# Access Compliance Report

## Public Rights-of-Way

### (Curb Ramps)

Intersection ID: 10026307	Main Street: FAIRVIEW_RD	Cross Street: LIBERTY_ROW	Location: SE
ADA ID: 127D4B9D4F8C	Ramp Type: Directional1	Initial Pass/Fail: Fail	Overall Compliance: No
Severity Score: 37.5			
Codes/Mitigation Info/Possible Solution		Field Measurements/Component Compliance

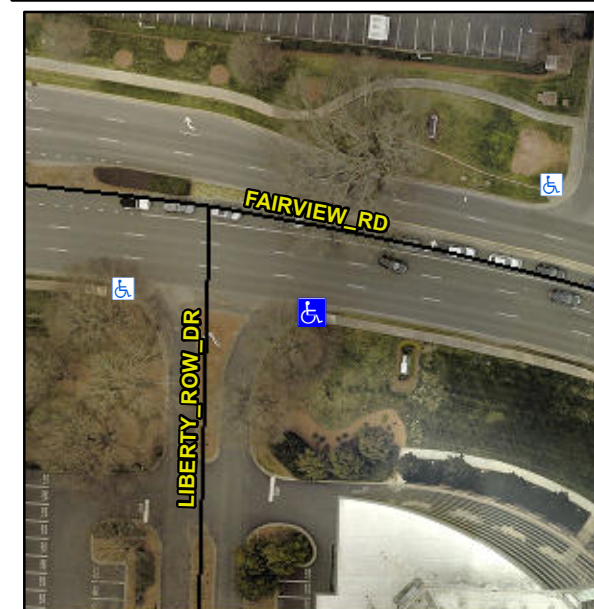
**R304.2.2, R304.5.3**

Compliance	Description	Data	Compliance	Description	Data
N/A	Ramp Length (in)	56.0	N/A	Grade Break?	N/A
Yes	Ramp Width (in)	60.0	N/A	Grade Break Slope (%)	0.0
No	Ramp Slope (%)	9.6	N/A	Grade Break XSlope (%)	0.0
No	Ramp XSlope (%)	12.2			
N/A	Flare Type LT	N/A	N/A	Flare Type RT	N/A
N/A	Flare Slope LT (%)	N/A	N/A	Flare Slope RT (%)	0.0
N/A	Flare Traversable LT?	N/A	N/A	Flare Traversable RT?	N/A
N/A	Landing Length (in)	0.0	N/A	DWS Provided?	N/A
N/A	Landing Width (in)	0.0	N/A	DWS Contrast?	N/A
N/A	Landing Slope (%)	0.0	N/A	DWS Length (in)	N/A
N/A	Landing X Slope (%)	0.0	N/A	DWS Full Width?	N/A
N/A	Landing Curb? (Y/N)	N/A	N/A	DWS Offset LT (in)	N/A
N/A	Shared Landing?	N/A	N/A	DWS Offset RT (in)	N/A
N/A	Gutter Ponding?	0.0	N/A	Gutter Slope (%)	N/A
N/A	Gutter Lip Ht (in)	0.0	N/A	Gutter X Slope (%)	N/A
N/A	Painted X Walk1?	No		Road Slope (%)	1.0
	X Walk 1 Direction	To W		Road X Slope (%)	2.5
	X Walk 1 Width (in)	N/A		Clear Space?	N/A

**Remove & Replace Entire Ramp.**
